D.H.C. FOUNDATION INVESTIGATION
W.P. 277-60 -- W.J. 60-F-42.

Re: - 20-Mile Creek and Highway No. 56 -
(Approx. 1.6 Miles North of Binbrook)
Twp. of Binbrook, County of Wentworth.
W.J. 60-F-42 -- W.P. 277-60 -- Dist. 4.

Proposed Structure at the Crossing of Twenty Mile
Creek Diversion and Hwy. #56 - Township of Binbrook
County of Wentworth - District No. 4 (Hamilton)
W. O. 60-11042 W.P. 277-60

This Section has reviewed the Bridge Drawings
(Nos. D-6956-1, 2 and 3) , dated December 1970 for the afore-
mentioned structure; the following comment is submitted.

APPROVED	DATE	BY	CONTRACT	NO.	W.P. No.
DESIGN	A.R.S.	CHECK	W.J.O.	37-114	277-60
DRAWING	W.J.O.	CHECK	W.J.O.		
DATE	FEB. 63	LOADING	1/20 S-6	DRAWING	D-2704-P

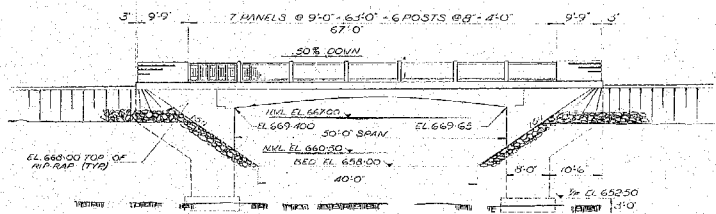
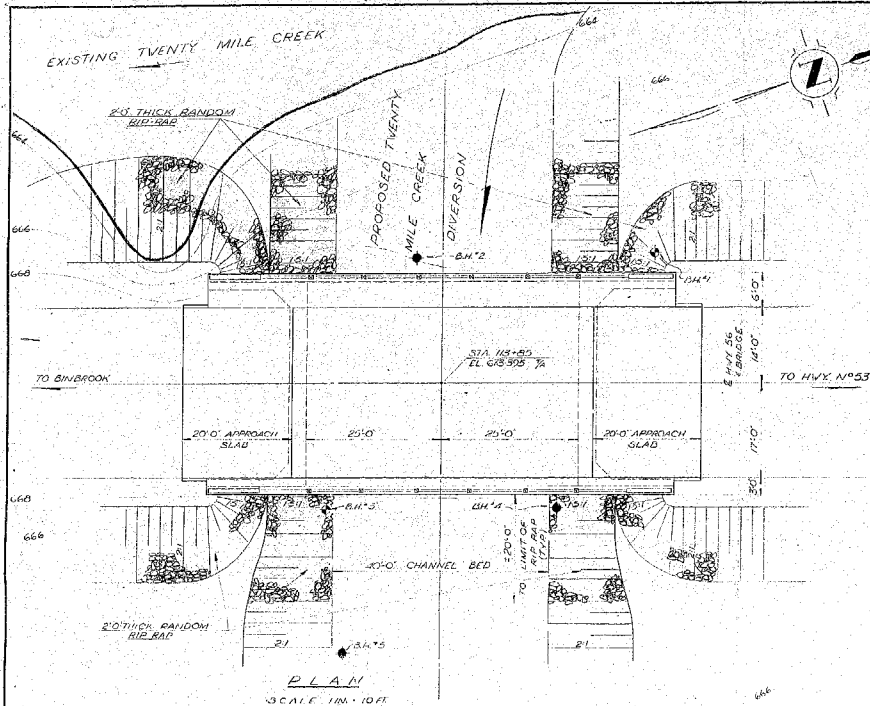
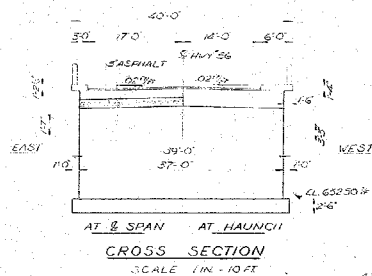
Enclosed is one (1) print of our preliminary
plan D 4704-P for the subject structure.

If you have any comments please let us know.

*No comment - footings founded
on bedrock
March 7, 1963. A. Stermac*

FOOTING & FRAME DETAILS

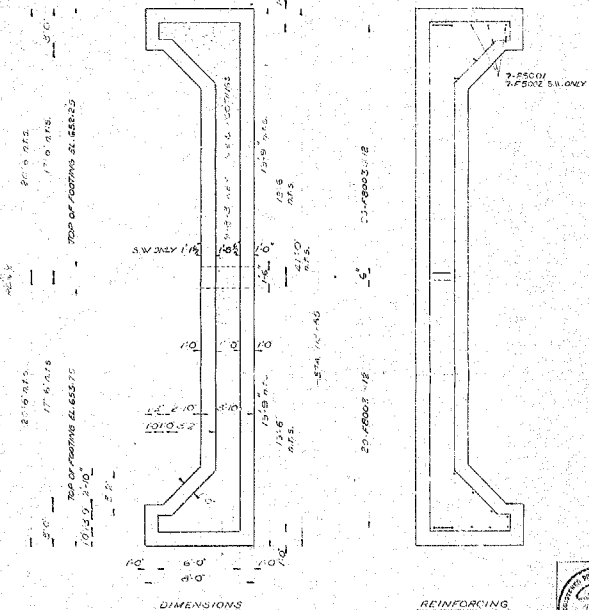
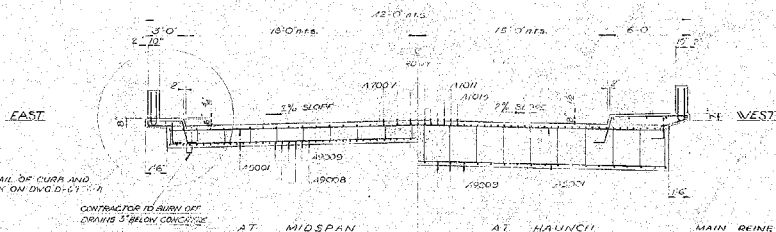
The groundwater in this area contains a high sulphate
concentration, which would have a detrimental effect on the
concrete in the abutment foundations. A sulphate resistant
cement should, therefore, be employed as per enclosed memo from
Mr. A. Rutka, Materials and Testing Engineer, dated June 4, 1963.
This provision should be contained in the "Special Provisions"
section of this contract. A copy of this letter is appended to
this memo.
